TOWN OF LEXINGTON PLANNING OFFICE

Re: 128 Spring Street/99 Hayden Avenue – Preliminary Site Development and Use Plan: PD-6

Date: January 28, 2022

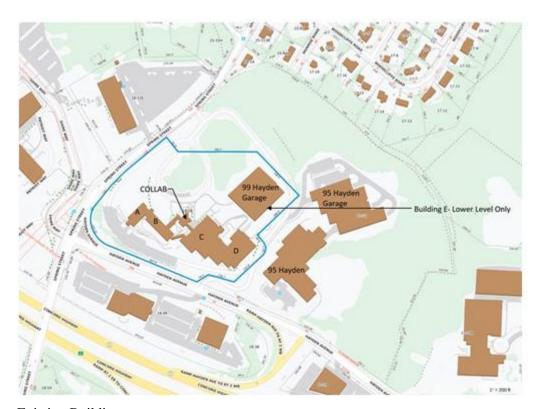
- Please note that the Massachusetts Department of Transportation limits signs visible to Route 2: see 700 CMR 3.00. Certain signs may not be allowed.
- Please note that the provisions of 6.4 Wireless Communications facilities will apply
- Is work proposed at the entrance drive off Spring Street?
